QUALITY ASSURANCE -- NON-CONFORMANCE REPORT

Report No: NCR-000861

Reference Description: Lift 5 West Shaft: Missed MT Crack at Skin D and Transverse Plate

To:	AMERICAN BRIDGE/FLUOR, A JV 375 BURMA ROAD OAKLAND CA 95607	Date:	14-Oct-2010
Dear:	Mr. Charles Kanapicki	Contract No:	04-0120F4 04-SF-80-13.2 / 13.9
Attention:	Mr. Thomas Nilsson Project/Fabrication Manager	Job Name:	SAS Superstructure
Subject:	NCR No. ZPMC-0823	Document No:	05.03.06-000818
Reference Description:	Lift 5 West Shaft: Missed MT Crack at Skin D and Transverse Plate

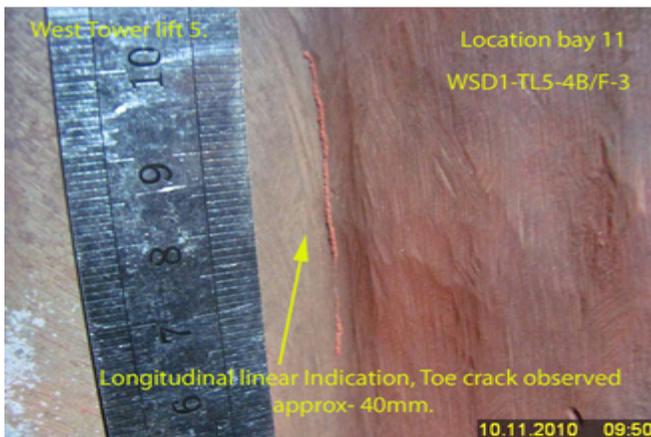
During the Quality Assurance (QA) Magnetic Particle Testing (MT) review of welds located in West Tower lift 5 Grillage plate, WSD1-TL5-4B/F-3, this Quality Assurance (QA) Inspector discovered the following issues:

- One longitudinal toe crack measuring approximately 40mm in length.
 - The weld is identified as: WSD1-TL5-4B/F-3.
 - The Weld is a Complete Joint Penetration (CJP) weld, joining the grillage plate to skin plate.
 - The material is Non Seismic Performance Critical Member (NON SPCM)
 - The member is located in Bay 11.
- The Notice of Witness Inspection Number (NWIT) is 06917. The indication is located on CJP weld area that has been previously tested and accepted by ZPMC Quality Control (QC) personnel. As per the contract documents, ZPMC's QC personnel are required to perform 100% MT inspection of this weld. The attached photographs provide additional detail.

ZPMC acknowledged the indication was missed and has issued an internal NCR to address this problem. ZPMC has repaired the indication and is providing the NDT record to show the acceptance of this weld. Based on this, ZPMC is requesting closure of this NCR.

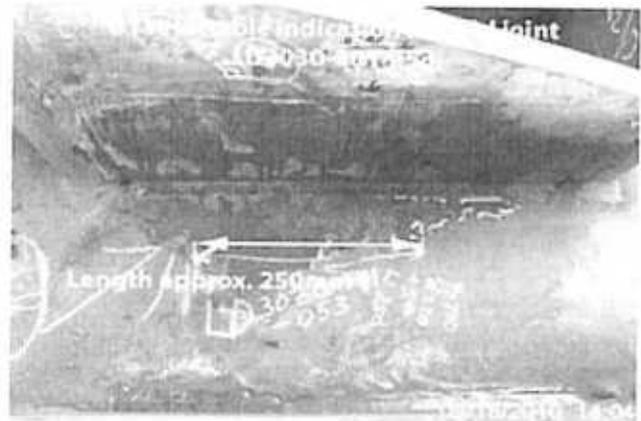
During the Quality Assurance (QA) Ultrasonic Testing (UT) review of welds located on Orthotropic Box Girder (OBG) segment 13BE and 13CE, this QA Inspector discovered the following issues:

- Three (3) longitudinal linear class "A" rejectable indications measuring approximately 180mm~260mm in length.
- The welds are identified as LD3028-001-031, LD3027-001-026 and LD3030-001-053.

- Material thickness for all joints is 30mm.
- The indication db rating for joint LD3028-001-031 is a +6.
- The indication db rating for joint LD3027-001-026 is a +4.

- The indication db rating for joint LD3030-001-053 is a +5.
- The depth of the indications are from 20mm~23mm deep.
- The Weld LD3028-001-031 is joining longitudinal diaphragm (X3682A) to lifting Lug.

These welds were designated to be PJP welds and no UT is required. The NWIT were submitted due to the internal fault between the floor QC & NDT operator of ZPMC. ZPMC is providing the MT records to show the acceptance of these welds and is requesting closure of this NCR.

LONGITUDINAL DIAPHRAGM SUB-ASSY ~ MARK LD3030A
(TYPE 2) (Ø E3, LOOKING NORTH - DEVELOPED)

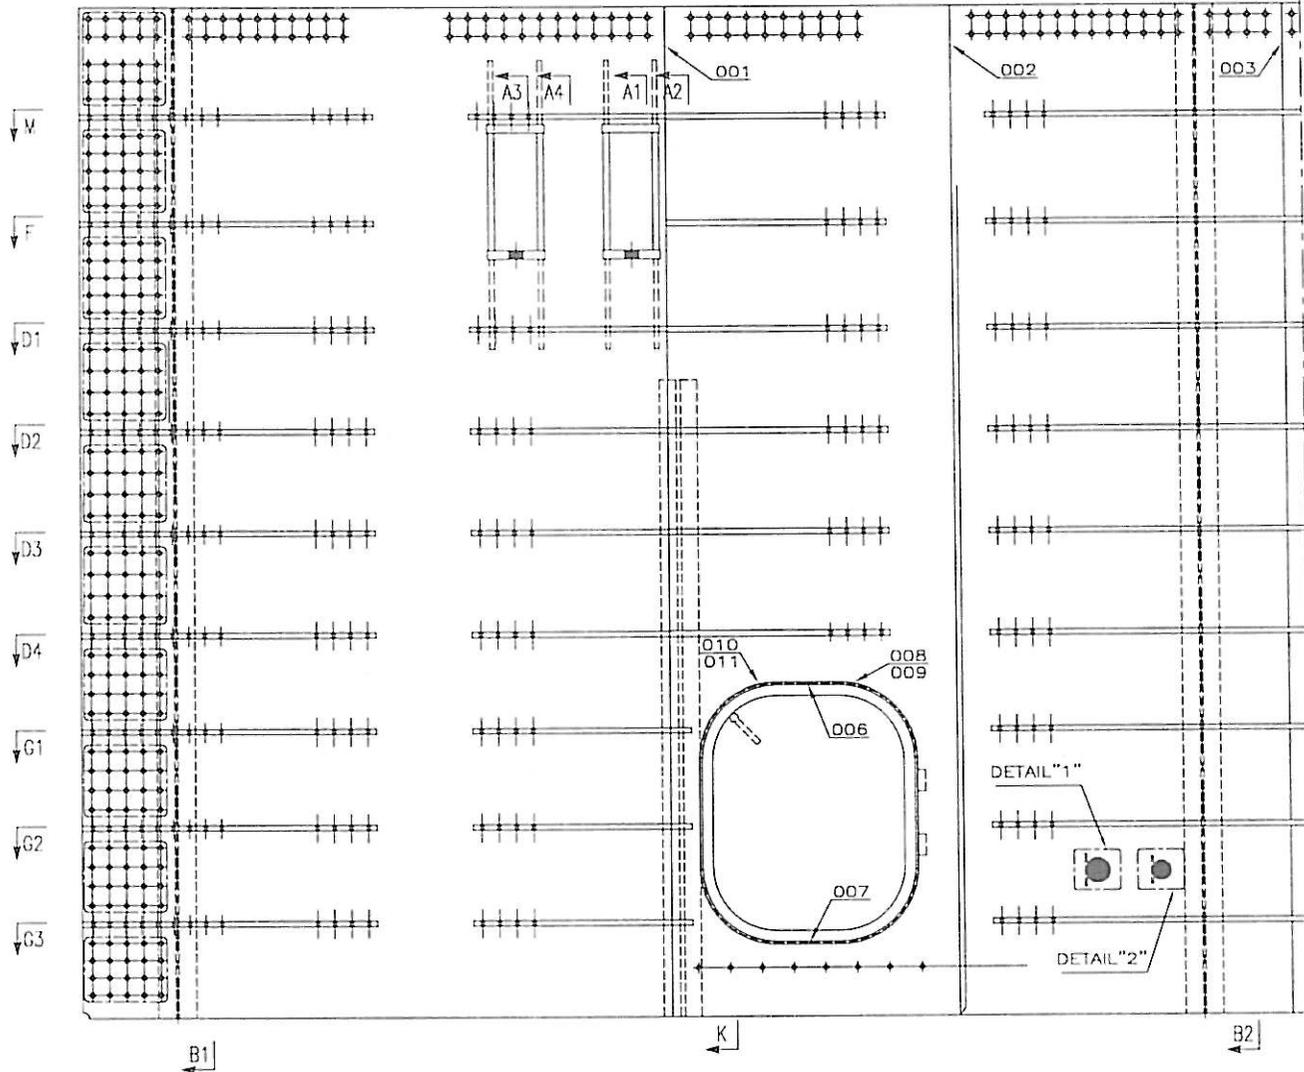
- The Weld LD3027-001-026 is joining longitudinal diaphragm (X3684B) to lifting Lug.
- The Weld LD3030-001-053 is joining longitudinal diaphragm (X3685A) to lifting Lug.

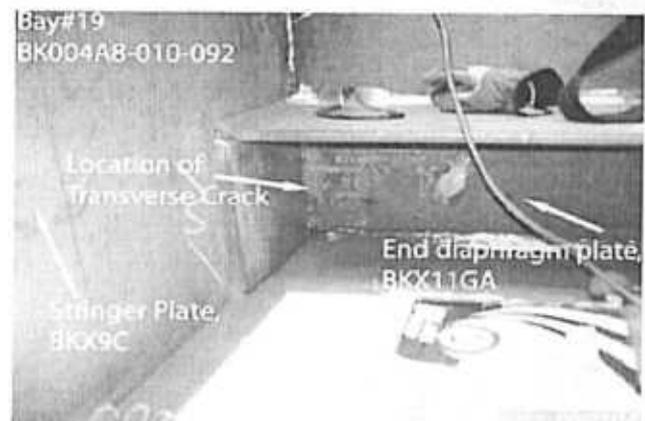
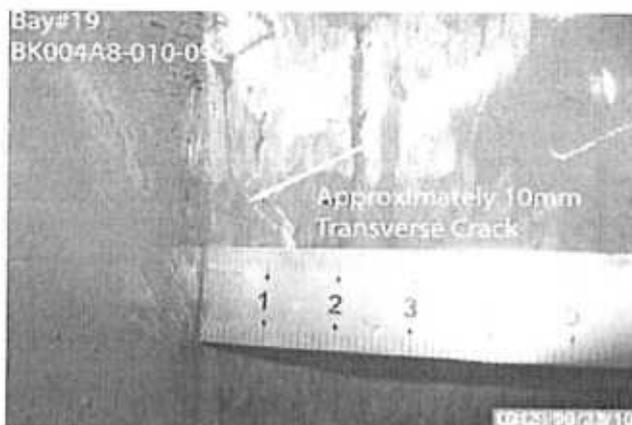
During the Quality Assurance (QA) Magnetic particle Testing (MT) review of welds located on OBG Bike path BK004A-010, this QA Inspector discovered the following issue:

- One transverse crack that measured approximately 10mm in length.
- The weld is identified as BK004A8-010-092.
- The weld is a Partial joint penetration (PJP) T joint, joining the Stringer plate (BKX9C) to the End diaphragm plate (BKX11GA).
- The Y Location is 100mm from the bearing plate.
- The OBG Bike path is located in BAY#19.
- This crack is clearly marked on the material on/near the weld.
- This weld joint is designated as Non-Seismic performance critical (Non-SPCM) weld member.
- The Notice of Witness Inspection Number (NWIT) is 006731.
- The crack is located within the area that has been re-tested and accepted by ZPMC Quality Control (QC) subsequent to the heat straightening procedure.

ZPMC acknowledged the indication was missed and has issued an internal NCR to address this problem. ZPMC has repaired the indication and is providing the NDT record to show the acceptance of this weld. Based on this, ZPMC is requesting closure of this NCR.

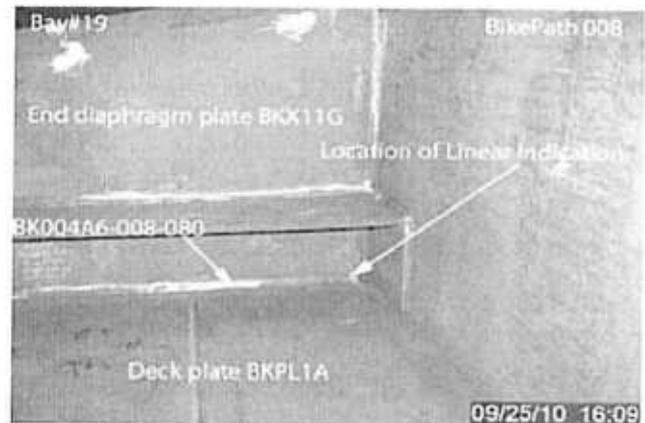
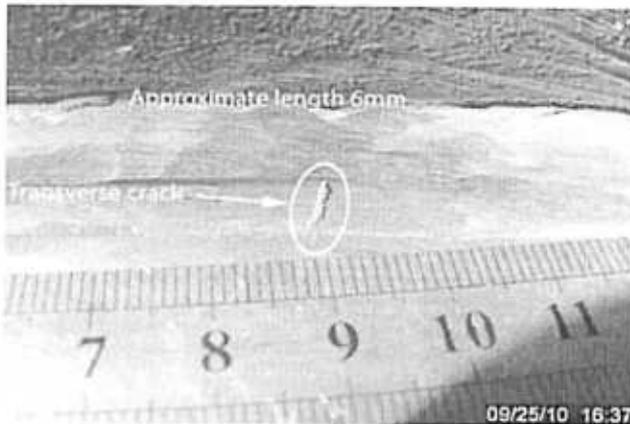
During the Quality Assurance (QA) Magnetic Particle Testing (MT) review of welds located on Bike Path 008, this QA Inspector discovered the following issues:

- One Longitudinal linear crack in the weld measuring approximately 15mm in length.
- The weld is identified as BK004A6-008-080.
- The weld is partial joint penetration (PJP), joining the End Diaphragm plate identified as BKX11G to the Deck Plate identified as BKPL1A.
- This weld joint is designated as Non-Seismic performance critical (Non-SPCM) weld member.
- The crack is clearly marked on the material near the weld.
- The OBG Bike Path 008 is located in Bay #19.

Quality Assurance (QA) Magnetic Particle Testing (MT) review of fillet welds located on OBG bike path BK004A-018, this QA Inspector discovered the following issues:

- One (1) transverse crack found on the weld measuring approximately 6mm in length.
- Y location of the indication is measured to be 2160mm.
- The crack is clearly marked on the weld joint.
- The weld is identified as: BK004A3-018-052.
- The Weld is a fillet weld joining the stringer plate (8C) to the deck plate of bike path.
- The member is located in bay 11.

ZPMC acknowledged the indications were missed and has issued an internal NCR to address this problem. ZPMC has repaired the indications and is providing the NDT records to show the acceptance of the welds. Based on this, ZPMC is requesting closure of this NCR.

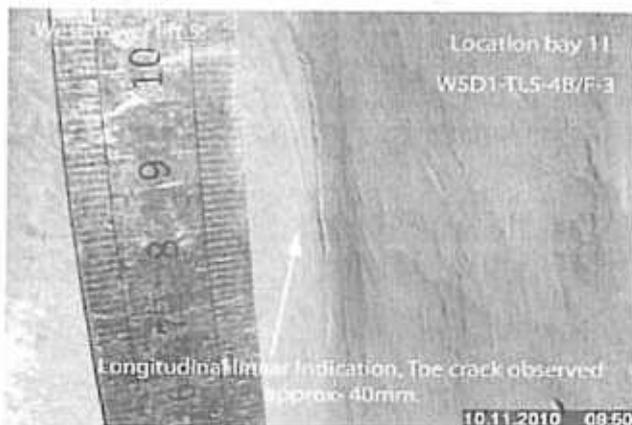
During the Quality Assurance (QA) Magnetic Particle Testing (MT) review of welds located in West Tower lift 5 Grillage plate, WSD1-TL5-4B/F-3, this Quality Assurance (QA) Inspector discovered the following issues:

-One longitudinal toe crack measuring approximately 40mm in length.

-The weld is identified as: WSD1-TL5-4B/F-3.

-The Weld is a Complete Joint Penetration (CJP) weld, joining the grillage plate to skin plate.

-The Notice of Witness Inspection Number (NWIT) is 06917. The indication is located on CJP weld area that has been previously tested and accepted by ZPMC Quality Control (QC) personnel. As per the contract documents, ZPMC's QC personnel are required to perform 100% MT inspection of this weld. The attached photographs provide additional detail.

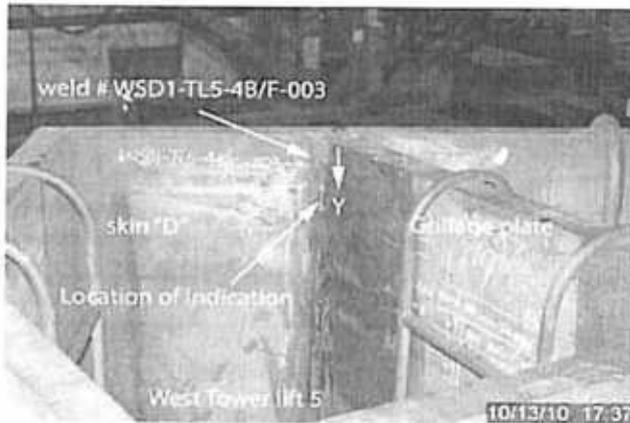
During the Quality Assurance Ultrasonic Testing (UT) verification of welds located on grillage plate of West Tower lift 5, this Quality Assurance (QA) Inspector discovered the following issues:

- One class "A" longitudinal indication measuring approximately 50mm in length.
- The depth of the indication is 57mm.
- The db rating is -2.
- The material thickness is 65mm.
- The weld is identified as: WSD1-TL5-4B/F-003.
- The Weld is a Complete Joint Penetration (CJP) with steel backing, T-joint, joining the grillage plate to the skin plate (skin "D").
- The "Y" location of the indication is 110mm from top side
- The indication is clearly marked on the component.
- The member is located in Bay 11.

The Notice of Witness Inspection Number (NWIT) is 06938. The indication is located inside the area that has been previously tested and accepted by ZPMC Quality Control (QC) personnel. As per the contract documents, ZPMC's QC personnel are required to perform 100% UT inspection of this weld.

-Attached photographs provide additional location details.

ZPMC acknowledged the indication was missed and has issued an internal NCR to address this problem. ZPMC has repaired the indication and is providing the NDT record to show the acceptance of this weld. Based on this, ZPMC is requesting closure of this NCR.

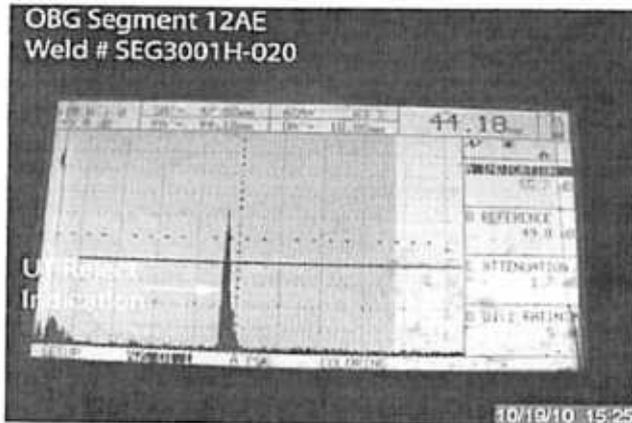
During the Quality Assurance (QA) Ultrasonic Testing (UT) verification of weld located on Segment 12AE, this QA Inspector discovered the following issue:
